Re: Brothers Green Nursery Application for Nursery Special Permit 11 Bedford Banksville Road, Section 102.04, Block 1, Lot 18

The foregoing changes are shown on the plan entitled "Existing Site Plan", prepared by Redniss & Mead, dated May 3, 2022, last revised June 13, 2022.

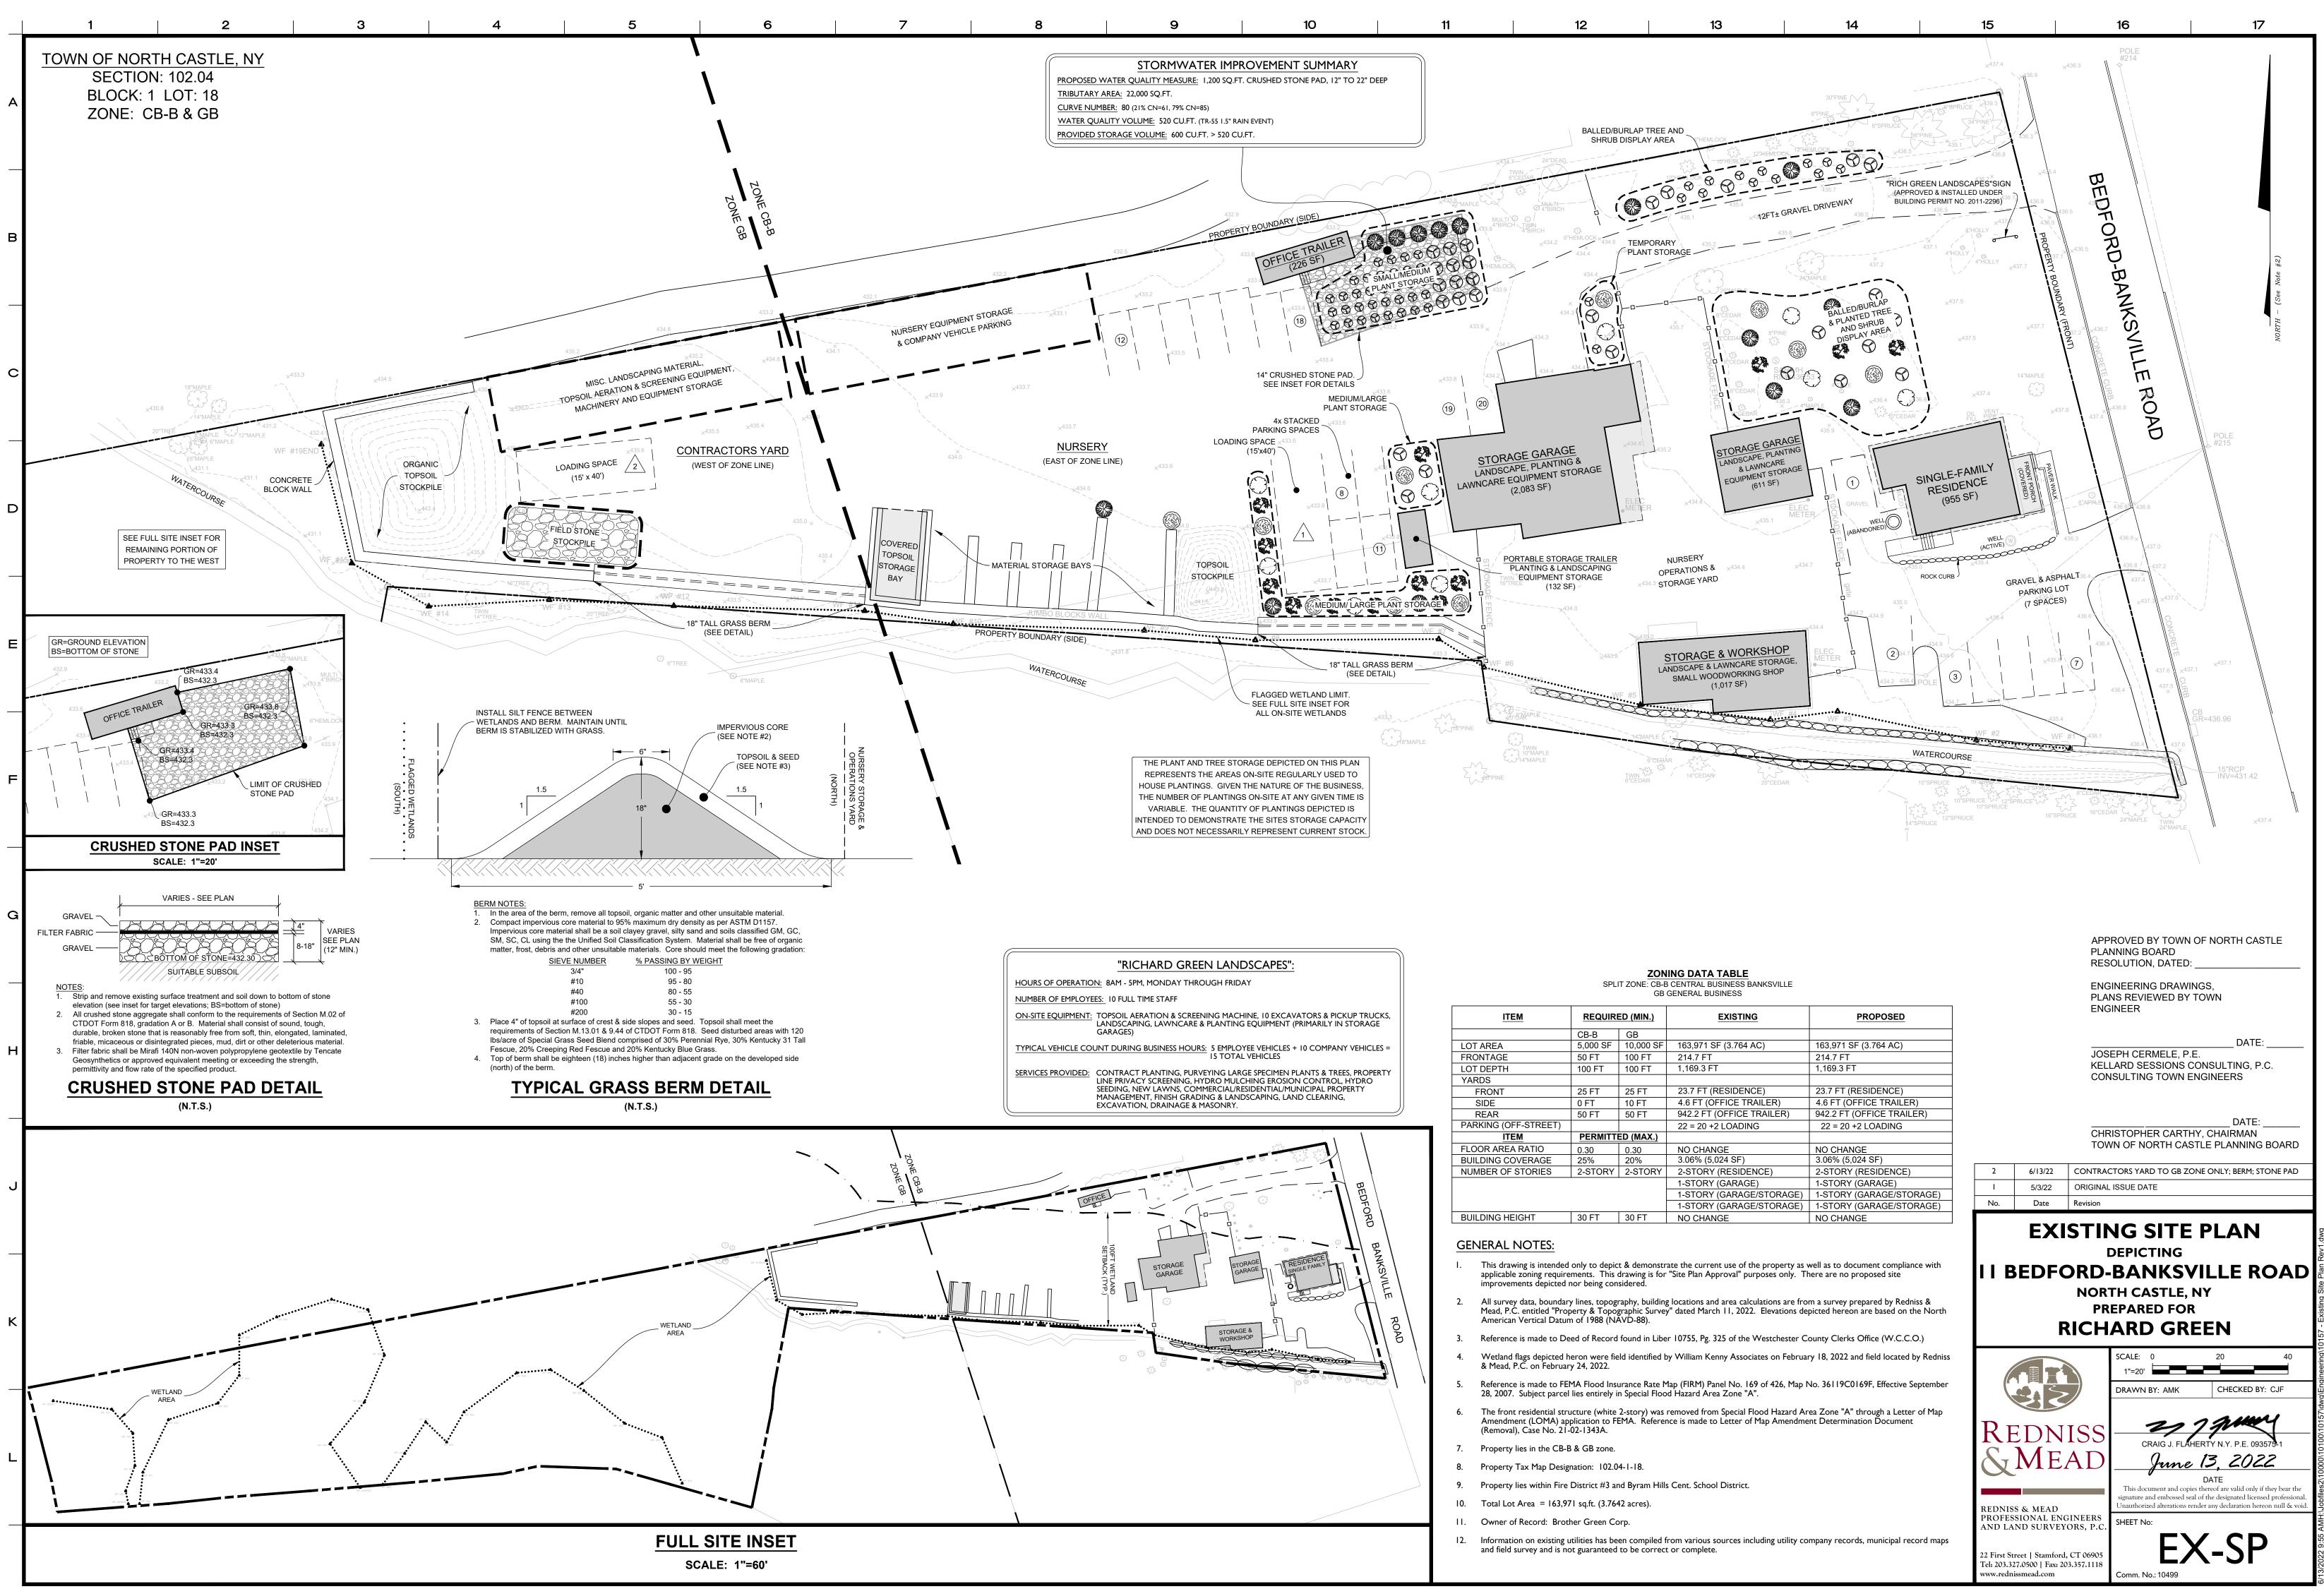
1. All equipment and materials associated with a contractor's yard have been relocated to the that portion of the Property that is within the GB zone, which permits contractor's yards by special permit.

- 2. Equipment and materials related to the nursery use have been located to that portion of the Property that is within the CB-B zone, which permits nurseries by special permit.

- 3. An 18-inch grass berm is proposed in two locations on the Property to provide additional protections for the wetlands. The berms are located on either side of the material storage bays. The two locations proposed protect the watercourse to the south from any potential runoff in that direction by acting as a barrier.

- 4. A crushed stone pad has been added adjacent to the office trailer at the existing low-point of the developed property. The quantity of stone provided is designed to provide storage to contain and infiltrate the 1.5 inch rain event, which is consistent with the water quality volume standards set forth in NYDEC Stormwater Manual. The stone pad will intercept stormwater generated from the majority of the rear "yard" area as well as the northern driveway to the east. This strategy was discussed with Kellard Sessions and deemed an acceptable stormwater quality improvement in concept.

- 5. All uses of buildings and surrounding areas have been clearly labeled.
